PANAMA CANAL AUTHORITY		VARIATION	PAGE 1 OF 2
1. REQUEST FOR PROPOSAL No.:	2. CONTRACT No.:	3. DATE:	March 5, 2012
RFP-76161	CMC-221427	4. VARIATION No.:	032

This Variation No. 32 is issued to replace Item No. 4. "National Police Station on Brujas Road", of the previously agreed upon Variation No. 25, and therefore, changing the Contractor's Limits at the Pacific Site as follows:

1. National Police Station on Brujas Road

THIRD SET OF LOCKS - PACIFIC SIDE  
CONSTRUCTION MANAGEMENT TEAM  
COCOL - BLDG. # 326

SKE-P-CM-MIC-004

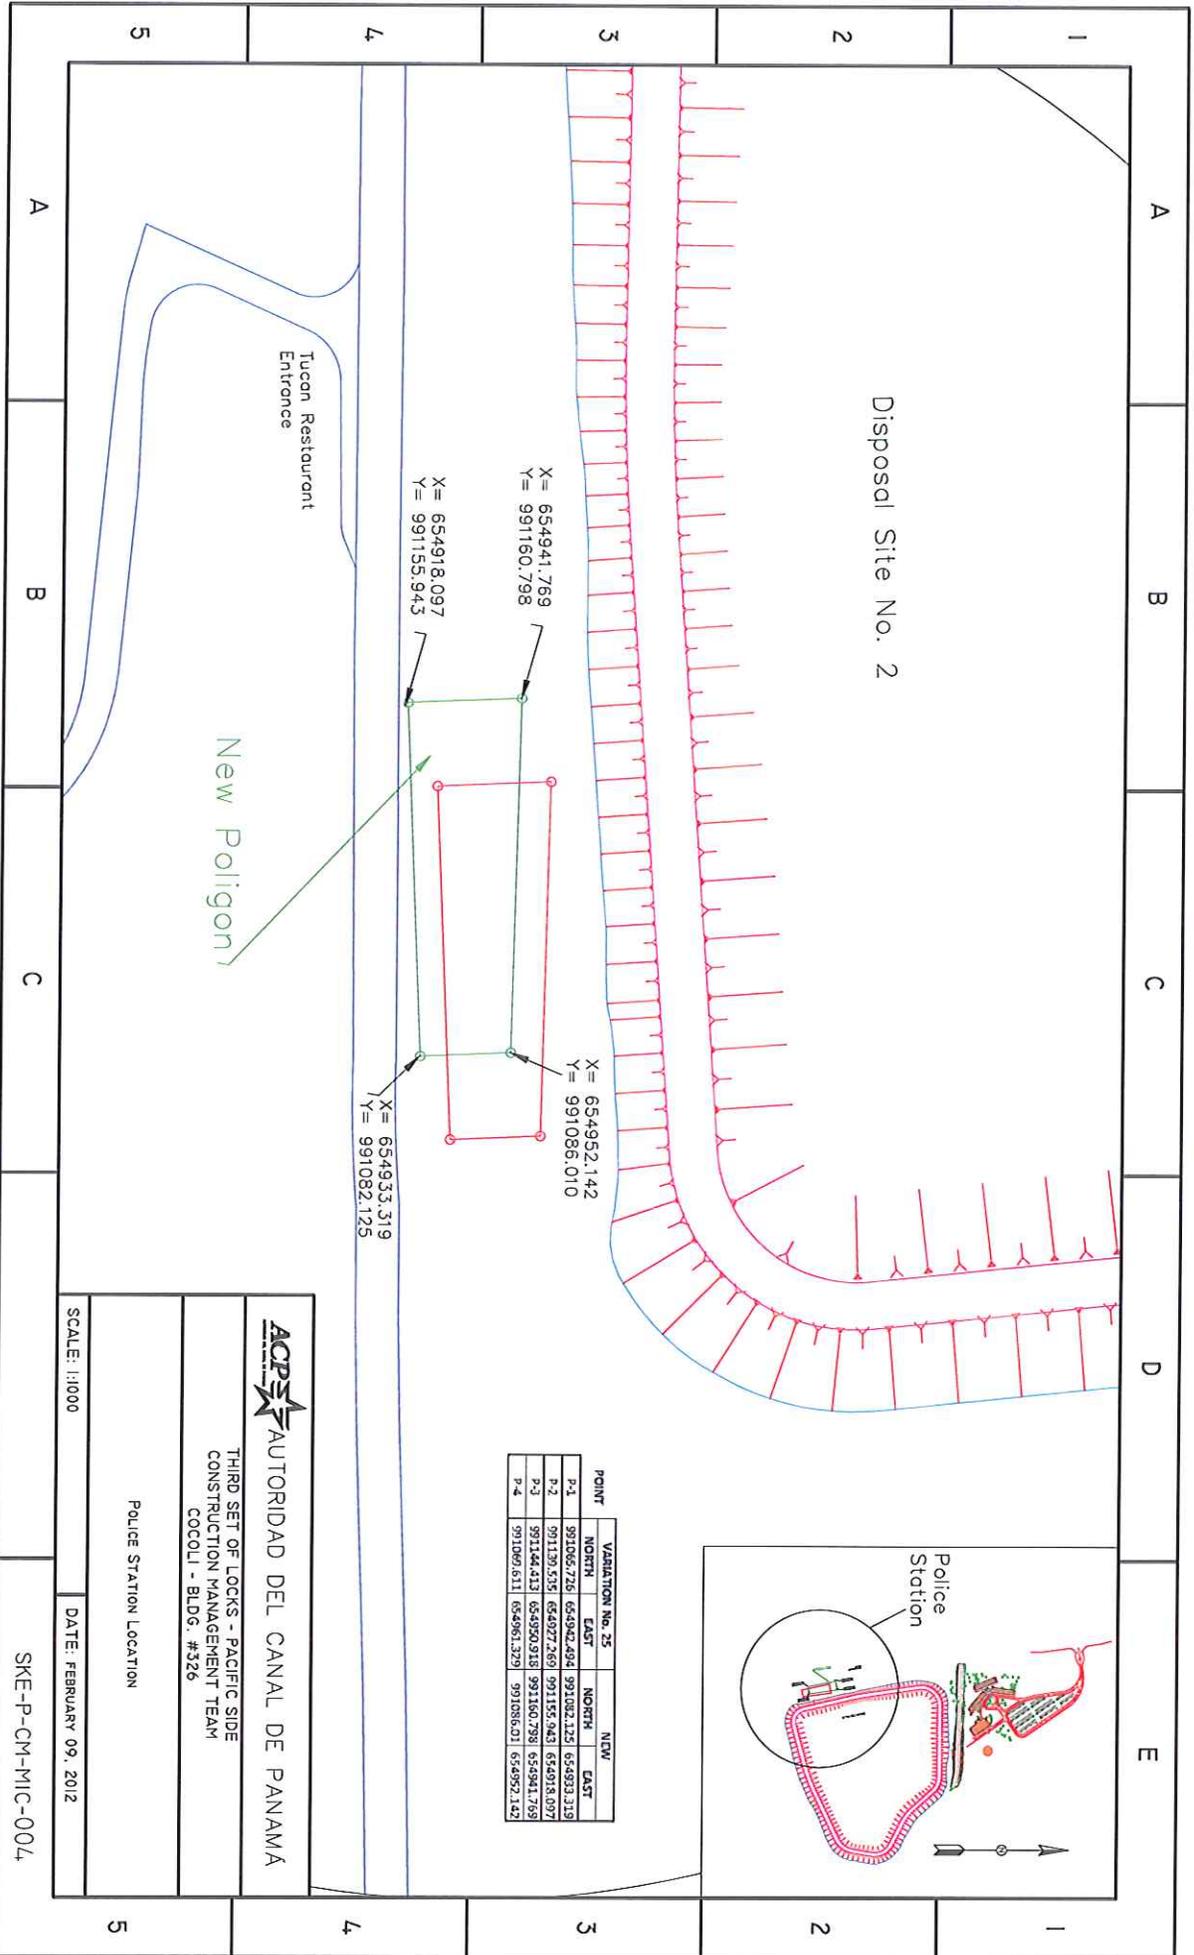
Removal of the area located within the Contractor's Polygon, as shown in the attached Drawing SKE-PC-CM-MIC-004, and as defined by the following coordinates:

Point	North	East
1	991155.943	654918.097
2	991160.798	654941.769
3	991086.010	654952.142
4	991082.125	654933.319

The Employer will relocate the Contractor's fence at the Employer's cost to accommodate a National Police Station and will also install any additional fencing that may be required to separate the area from the Contractor's Polygon.

POINT	VARIATION No. 25		NEW	
	NORTH	EAST	NORTH	EAST
P-1	991086.726	654982.294	991082.125	654933.319
P-2	991139.535	654927.269	991155.943	654918.097
P-3	991194.413	654950.918	991160.798	654941.769
P-4	991069.611	654961.329	991086.010	654952.142
